**TOWN OF GLASTONBURY**  
**GL-2017-39**  
**NEW ADDITION GLASTONBURY TOWN HALL**  
**ADDENDUM NO. 1**  
**August 11, 2017**

**Glastonbury  
Town Hall  
New Entry Addition  
GL-2017-39**

**PARTIAL DEMO  
PLANS**

**D-101**

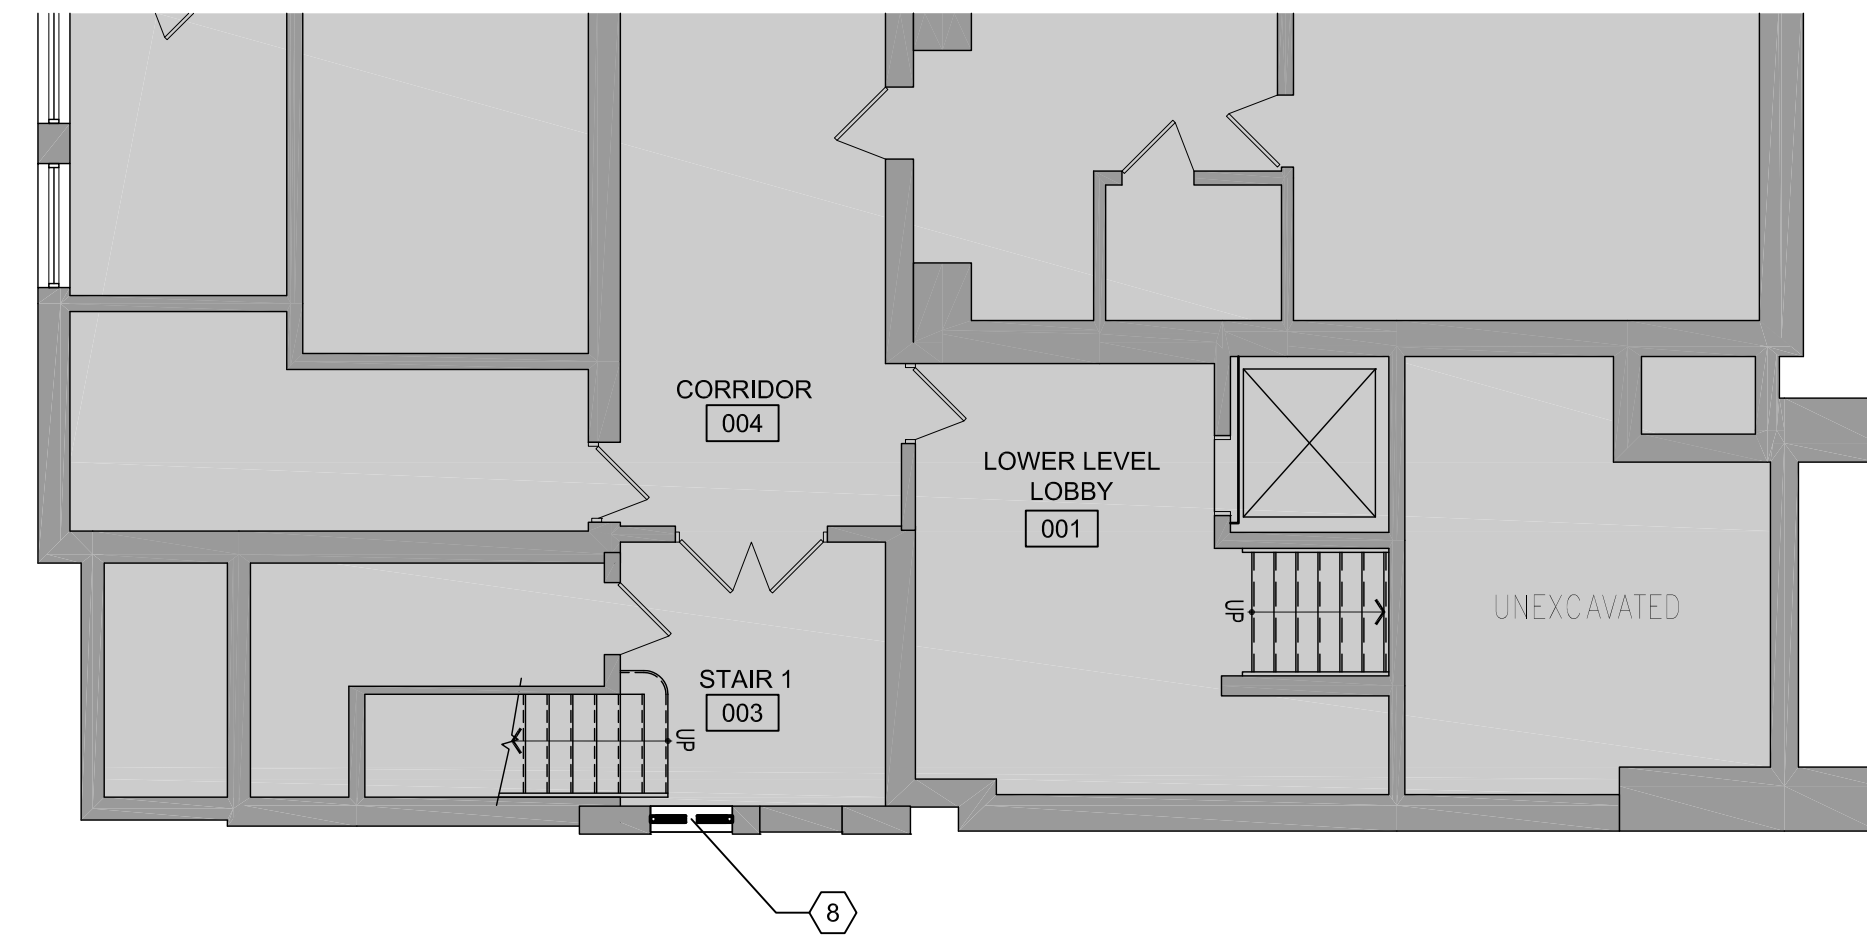
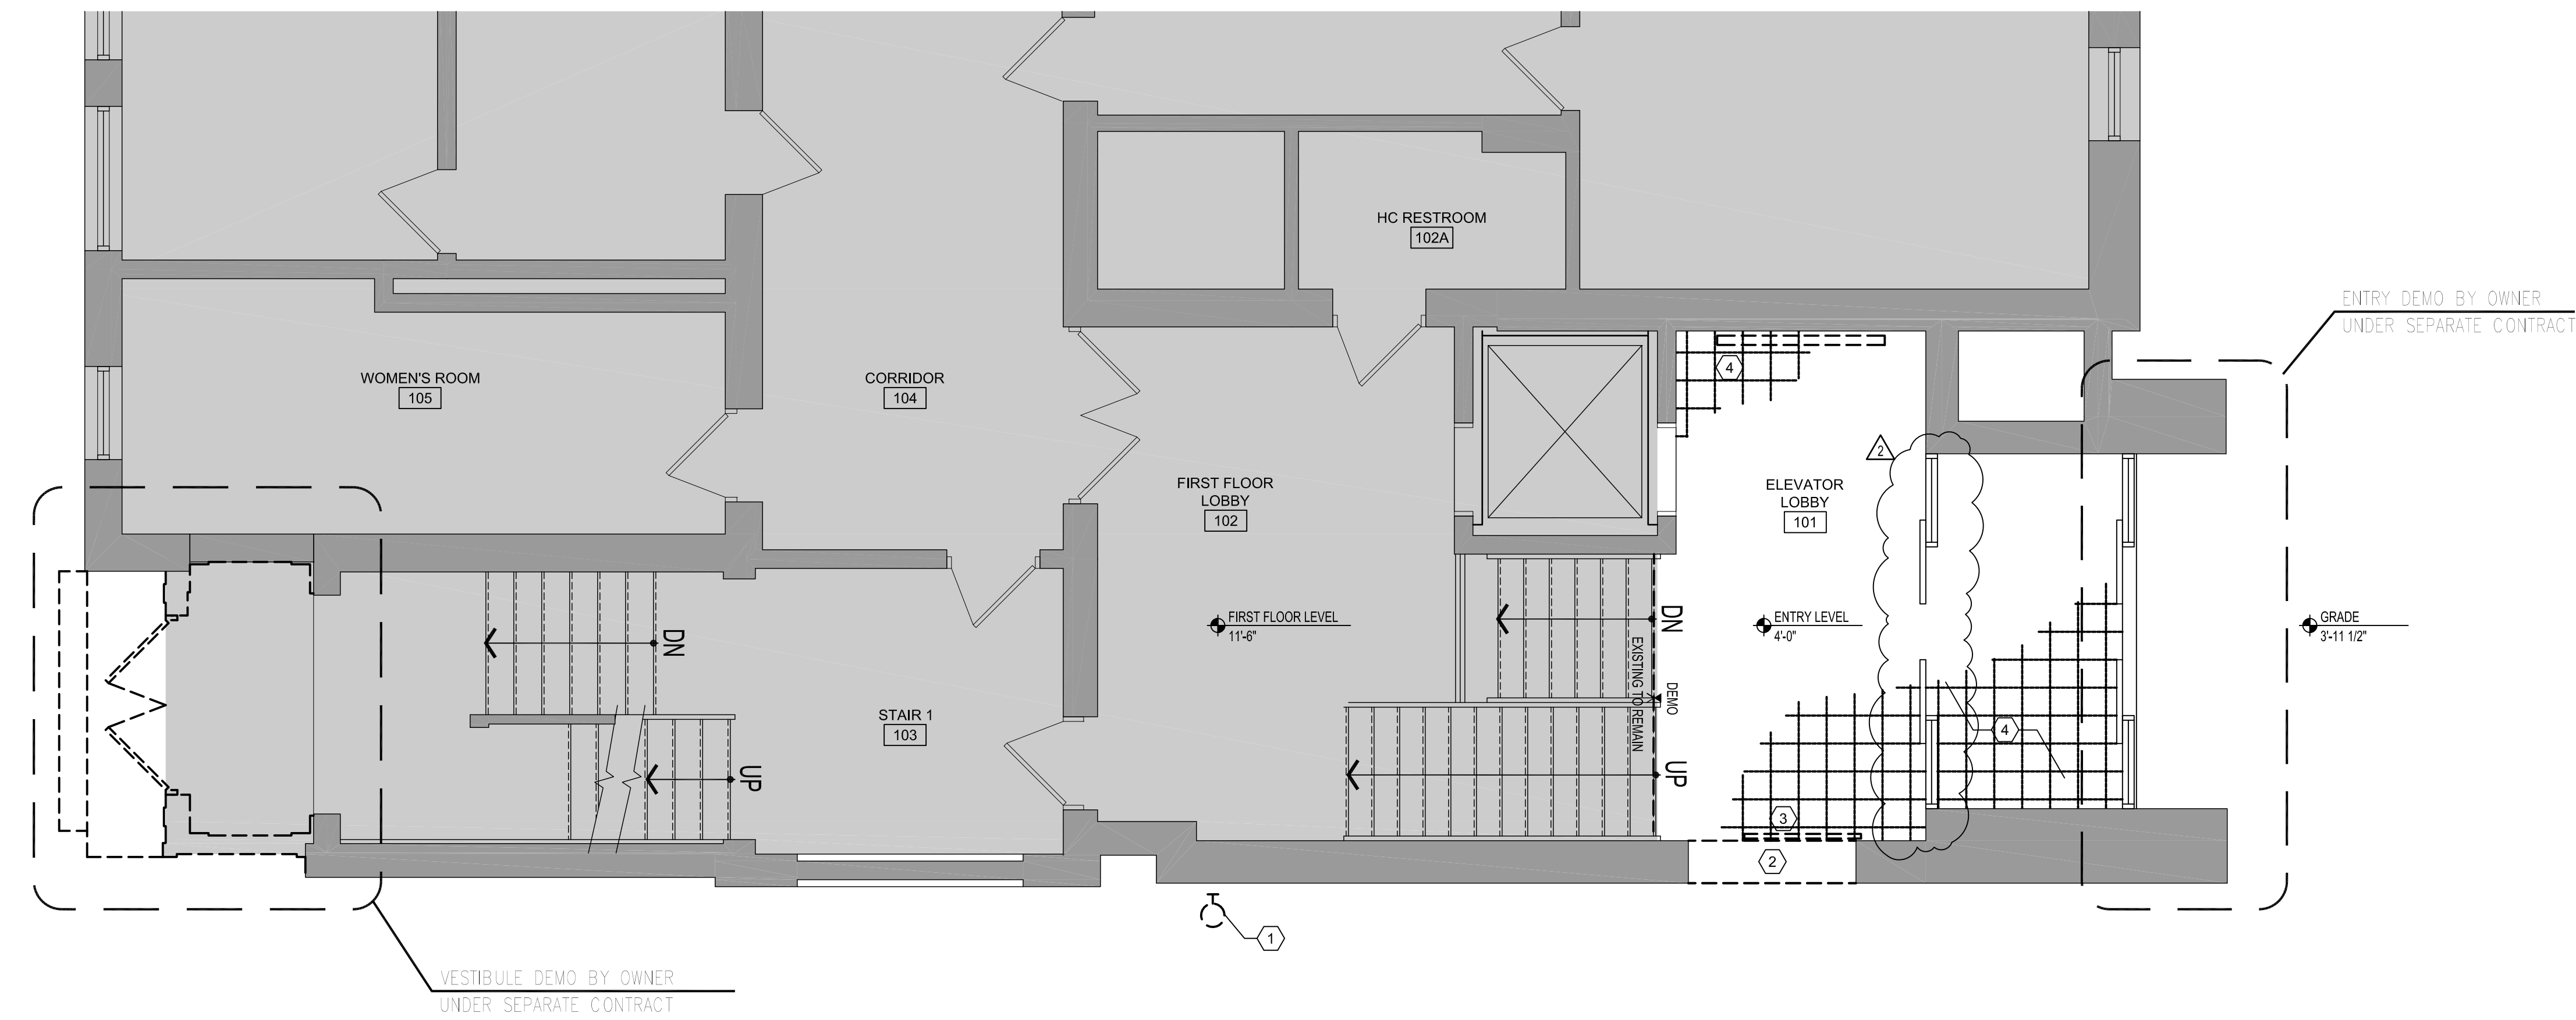
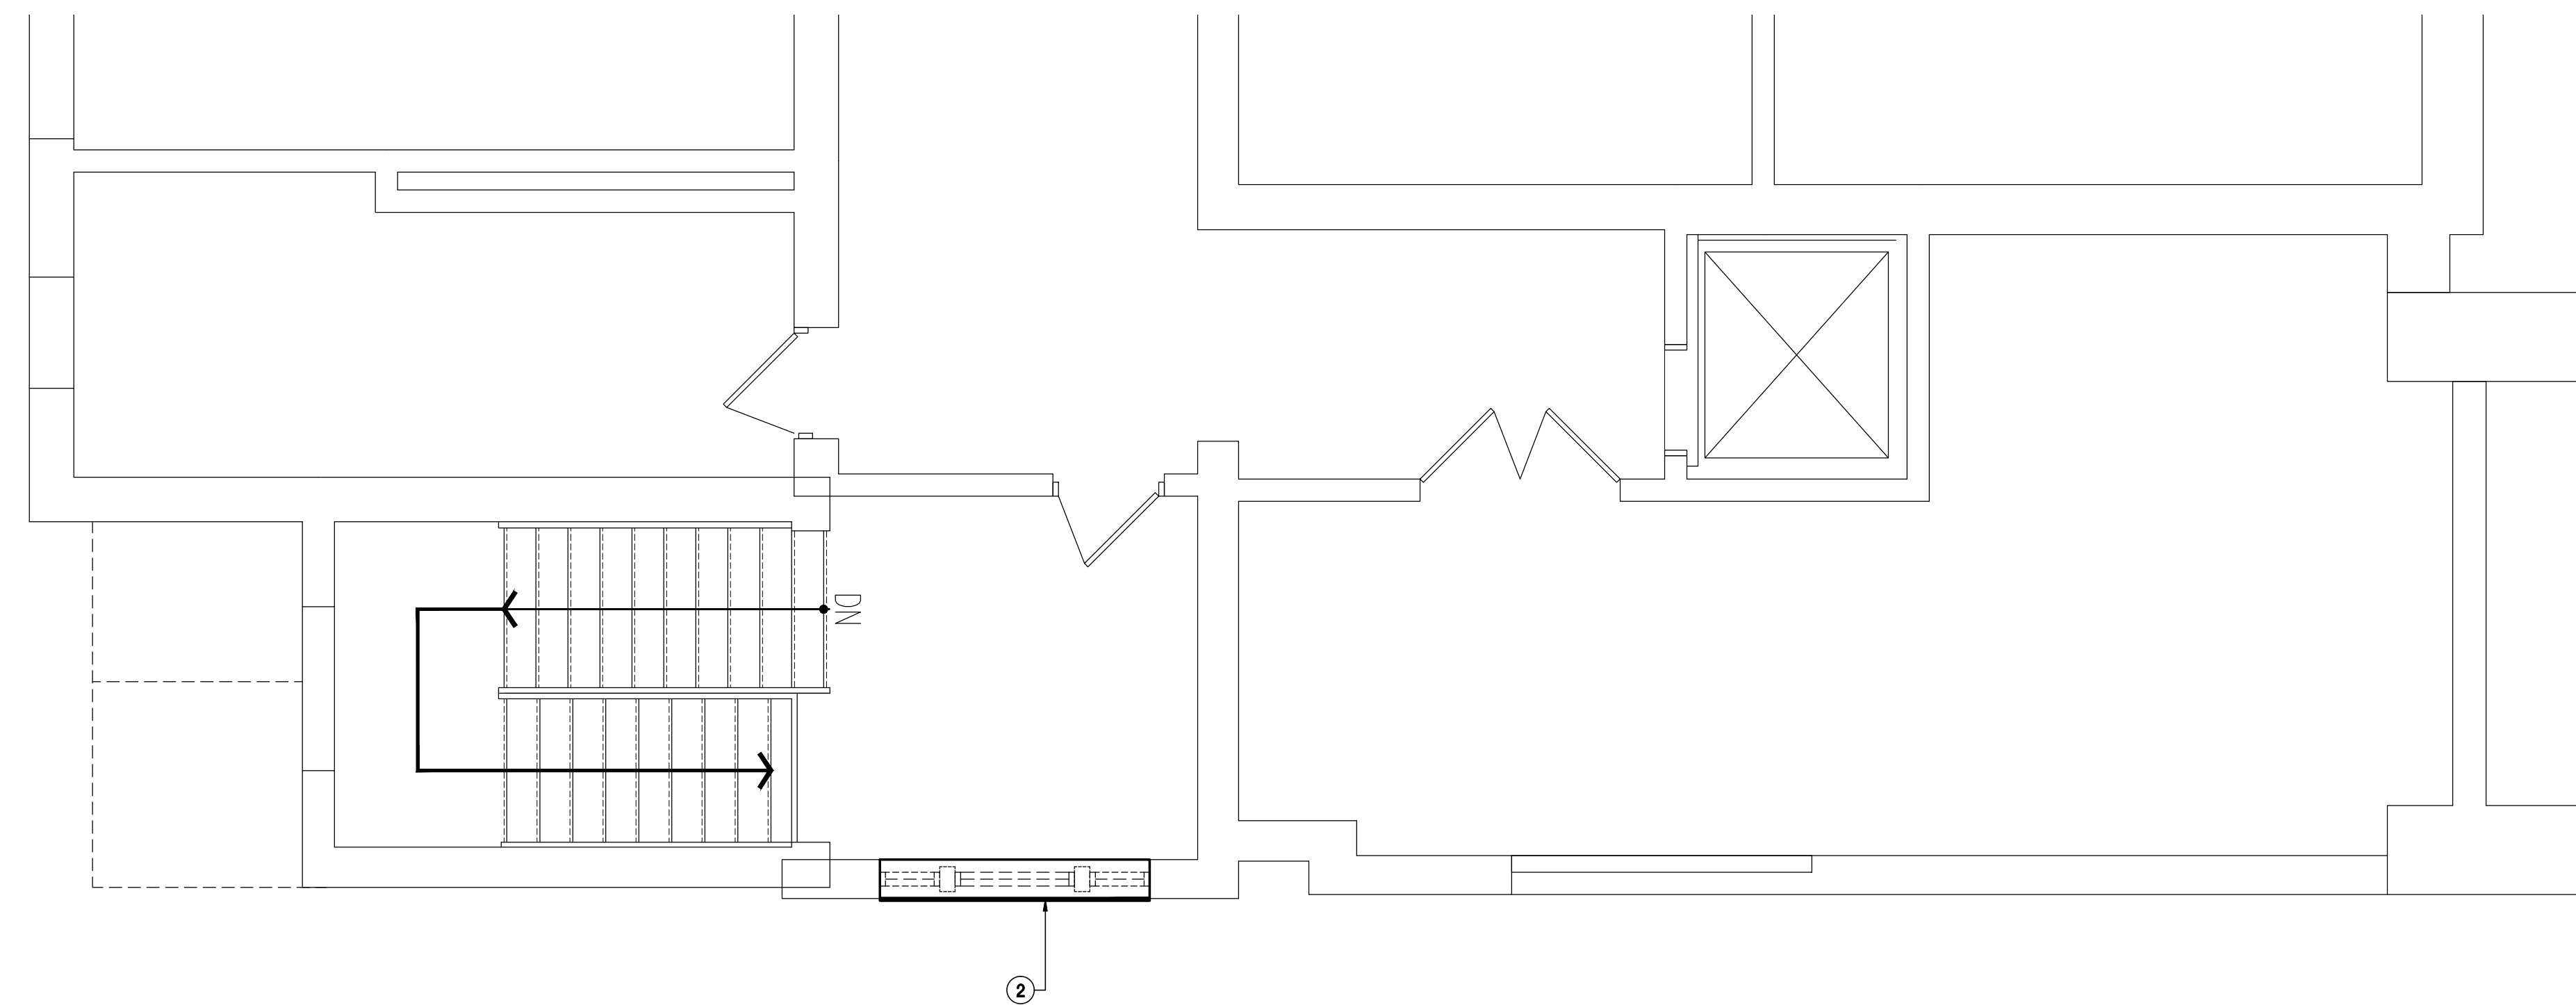
**Question 3:** *Kindly confirm that in existing and renovated Elevator Lobby 101 that our GC bid work is limited to:*

- a. removal and salvage of existing sliding door assembly*
- b. removal and replacement of exiting tile floor and base*
- c. Modifications to wall surround for new, cased, North entry into lobby 100*
- d. There is no ceiling ACT or painting work*

**Question 4:** *Please confirm if Item #9 on 3/D101 (window removal and infill) is part of our GC work?*

**Answer:** Existing interior sliding vestibule door removal will be by owner under separate project. All other items are correct. Drawing D101 has been revised as per the attached.

**Answer:** Correct.
